ARCHITECTURAL REVIEW BOARD STAFF REPORT

Project #/Name	ARB-2022-93: Galaxie Farm Townhomes Final Site Plan
Review Type	Final Site Plan and Preliminary Review of Architecture
Parcel Identification	09100-00-00-00900, 09100-00-00-01500
Location	192 and 193 Galaxie Farm Lane on the west side of Rt. 20, .3 miles south of the intersection of Mill Creek Drive and Rt. 20.
Zoned	Planned Residential Development (PRD) / Entrance Corridor (EC)
Owner/Applicant	Galaxie Farm Investments LLC / Riverbend Development, Inc., Collins Engineering (Scott Collins)
Magisterial District	Scottsville
Proposal	To construct 16 attached townhouses in one group of four units and two groups of six units as part of a larger development including 43 detached residences and associated site improvements on approximately 13.36 acres.
Context	The character of this portion of the Entrance Corridor is largely residential and rural. Some commercial properties are interspersed.

Visibility	See Project History/Visibility.
ARB Meeting Date	December 5, 2022
Staff Contact	Khris Taggart

Figure 2: Snippet from Sheet 18 of the Final Site Plan with Lots 18-27 and 54-59 highlighted.

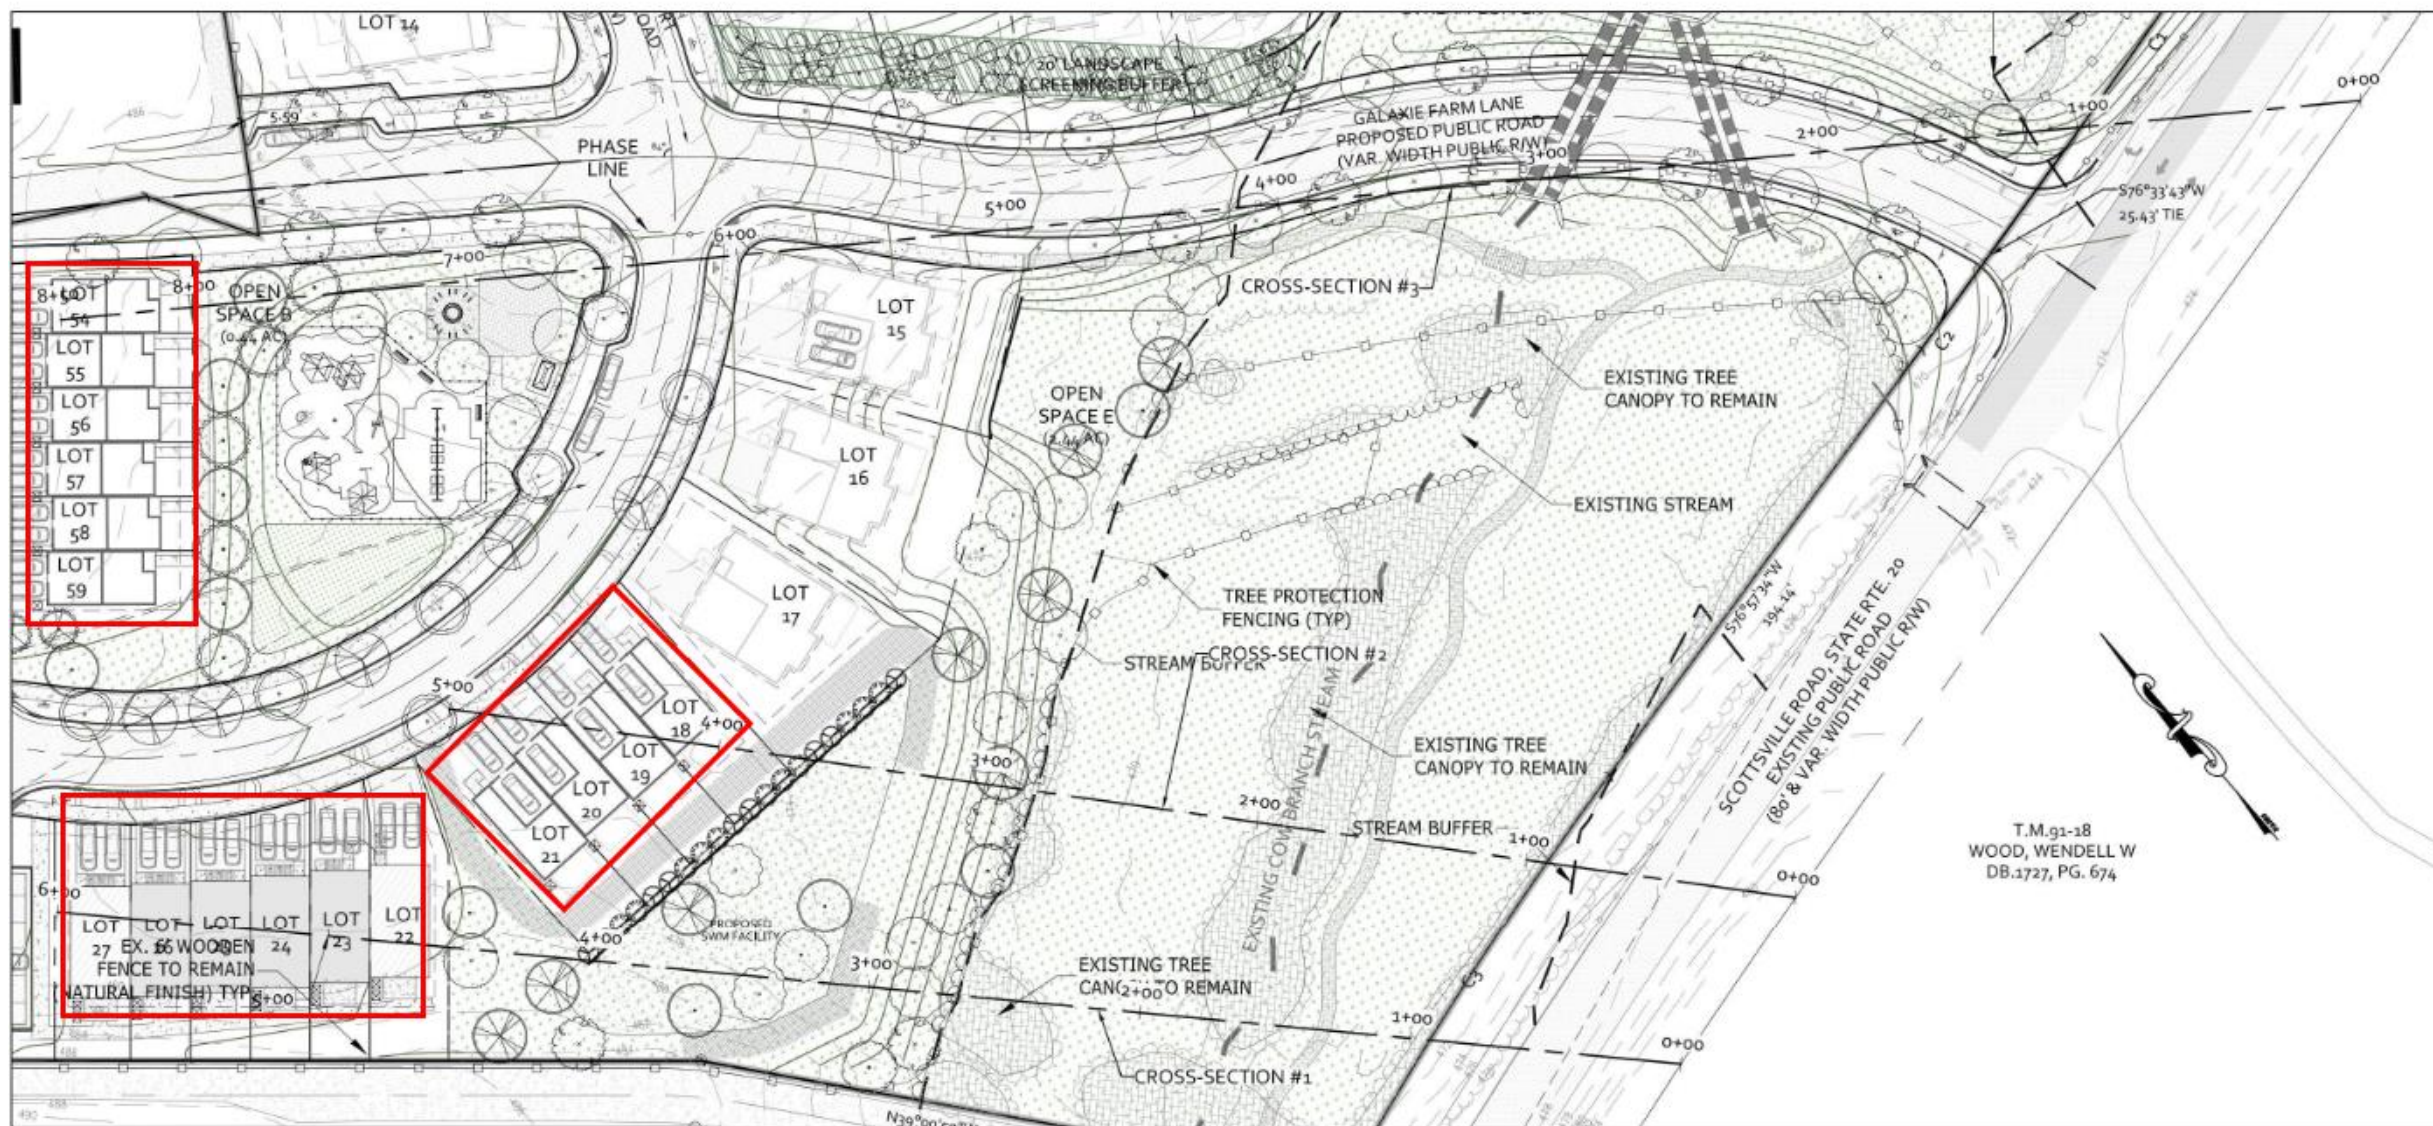
The ARB reviewed and recommended approval of the initial site plan, ARB-2021-76, at the August 16, 2021 ARB meeting. Entrance Corridor requirements apply to the townhome portion of this development and Galaxie Farm Lane. Assuming the height of the townhomes is similar to or less than that of the single-family detached units, Lots 18-27 and Lots 54-59 will have visibility from the EC (Fig. 2 and 3).
